Access Compliance Report Public Rights-of-Way (Curb Ramps)

Main Street: NEWPORT_BLVD Cross Street: COWAN_HEIGHTS_DR Location: SE

ADA ID: RPRK211012152507 Ramp Type: Type 1 - Perpendicular Diagonal Initial Pass/Fail: Pass Overall Compliance: No Severity Score: 0

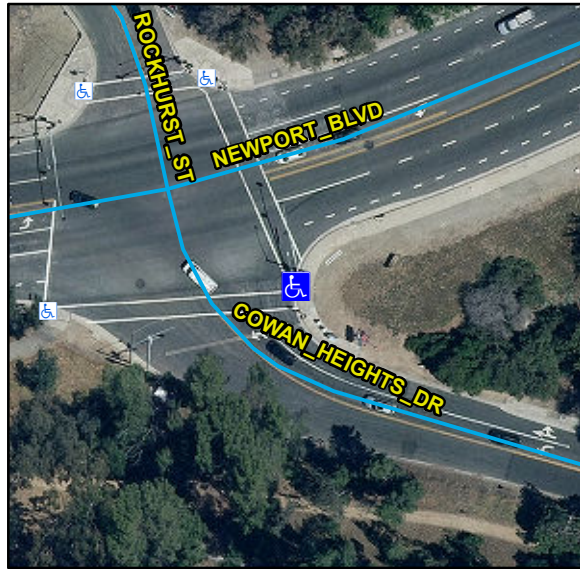
Yes	Ramp Inside Crosswalk 1	Yes	Yes	Ramp Inside Crosswalk 2	Yes
	Crossing 1 Slope (%)	1.1		Crossing 2 Slope (%)	0.3
	Crossing 1 Cross Slope (%)	5.1		Crossing 2 Cross Slope (%)	7.6
Yes	Gutter Ponding	No	No	Curb Slope	9.7
Yes	Gutter Lip Height (in)	0		Road Run Slope (%)	3.8
Yes	Gutter Run Slope (%)	1		Road Cross Slope (%)	2.7
Yes	Gutter Cross Slope (%)	1.3			
Yes	Overall Surface Condition: Acceptable		Yes	Perp Joint Present	Yes
	Cross Gutter Present?	No		Spandrel Present?	No
	Replace Cross Gutter?	N/A		Replace Spandrel?	N/A

Remove & Replace Curb Slope.

R304.2.2, STD 1115
